Intel® Pentium® Processor N3500-series, J2850, J2900 and Intel® Celeron® Processor N2900-series, N2800-series, J1800-series, J1900, J1750

Specification Update

April 2019

Figure 65. SPI NOR Timing

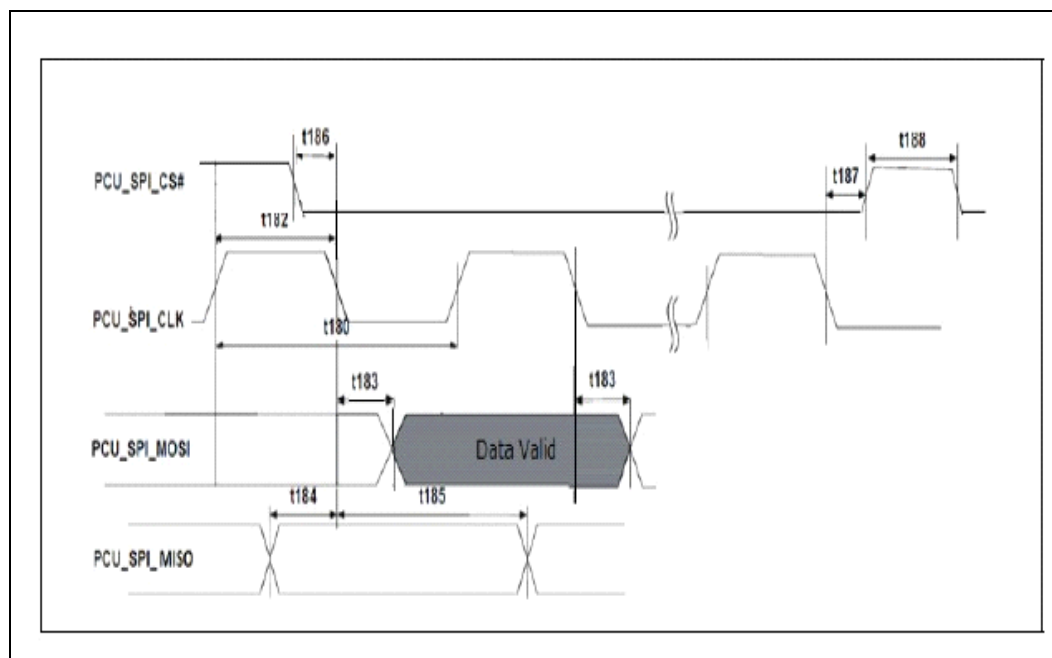
The setup of PCU_SPI_MISO with respect to serial clock falling edge at the host (t184) as stated in Table 131 PCU-SPI NOR AC Specification, of Section 9.6.18 PCU SPI NOR AC Specification, is listed as 11ns (min). After re-checking post validation and simulation data, the value of t184 can be revised down to 6ns (min).

Symbol	Parameter	Min.	Max	Units	Note
t180	Serial Clock Frequency	-	33	MHz	
t182	SPI Clock duty cycle at Host	45	55	%	
t183	Tco of PCU_SPI_MOSI with respect to serial clock falling edge at the host	-2	5	ns	
t184	Setup of PCU_SPI_MISO with respect to serial clock falling edge at the host	6		ns	
t185	Hold of PCU_SPI_MISO with respect to serial clock falling edge at the host	1		ns	
t186	Setup of PCU_SPI_CS[1:0]# with respect to serial clock falling edge at the host	12		ns	
t187	Hold of PCU_SPI_CS[1:0]# with respect to serial clock falling edge at the host	5		ns	
t188/ t189	Min Idle (de-assertion) time for PCU_SPI_CLK signals	32		ns	
Trise/ Tfall	Rise / Fall time	1	5	ns	1,2
